**STATE OF MINNESOTA
PUBLIC UTILITIES COMMISSION**

**XCEL ENERGY'S 2017 DISTRIBUTION SYSTEM /
HOSTING CAPACITY STUDY**

Docket E002/M-17-777

**FRESH ENERGY'S COMMENTS ON XCEL'S 2017 HOSTING CAPACITY REPORT
AND SUGGESTIONS FOR MODIFICATION OF FUTURE REPORTS**

Figure 1. Xcel chart titled “Steps Toward Interconnection”

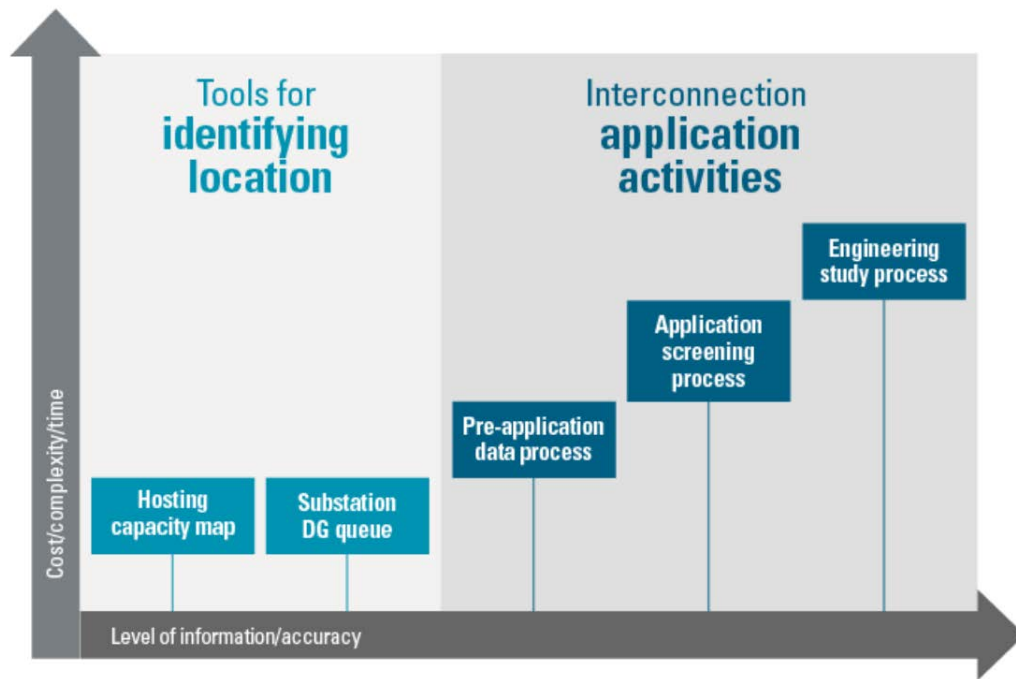
To reach this objective the DRIVE tool must continue to improve, Xcel must demonstrate accuracy of the results, and there must be a clear internal plan for integration of the tool. In response to the Commission’s information request asking how hosting capacity can be used to inform or improve the interconnection process, Xcel provided the chart below illustrating their view of the hosting capacity analysis as a tool for developers, separated from the application review steps, and with the lowest level of information/accuracy.¹

Additionally, Xcel’s report says that it is “still exploring how to best meet the range of interconnection needs” and also says that, “it is possible that an additional tool may be best suited if a future objective were to streamline detailed study analysis.”² This implies that

DRIVE may be insufficient to meet this long-term objective, in which case we recommend identifying other options as soon as possible.

Figure 2. Southern California Edison’s Integration Capacity Analysis (ICA) Results

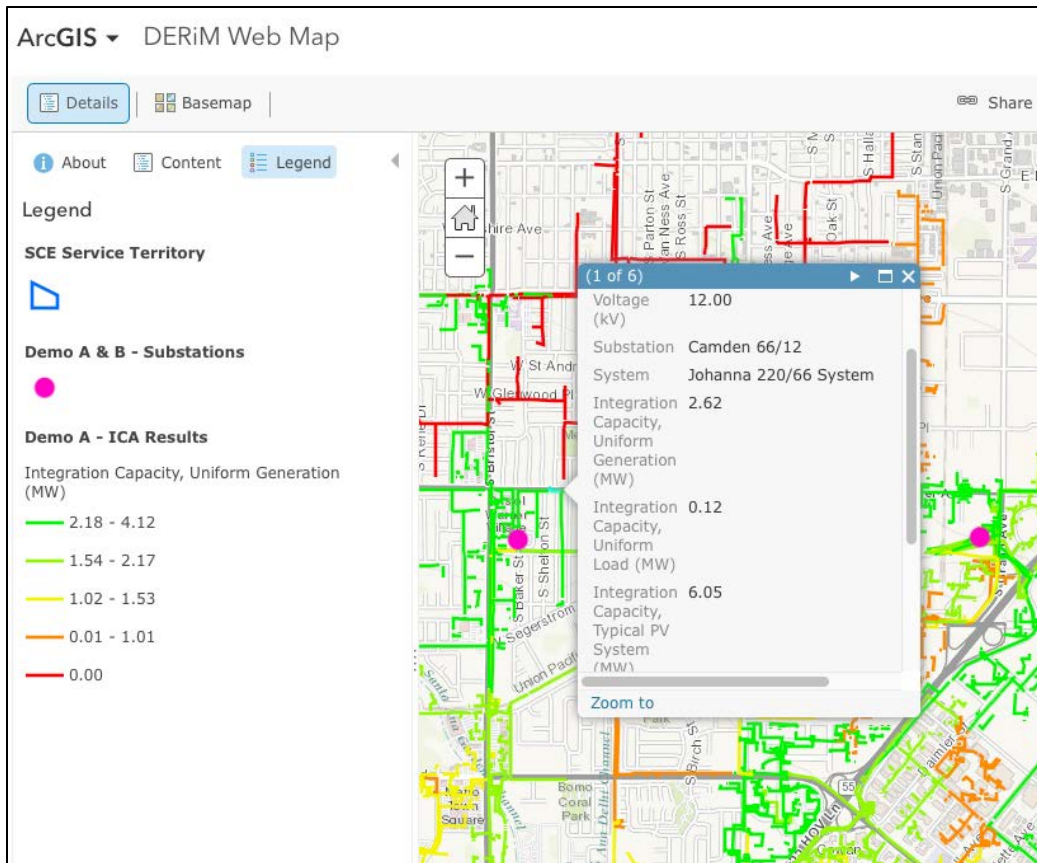
- Include “pop-up” windows to provide HC details, including limiting factors, for each node or line section. Figure 2 below shows a screenshot of some of the easily-

accessible information on Southern California Edison’s map, as an example.
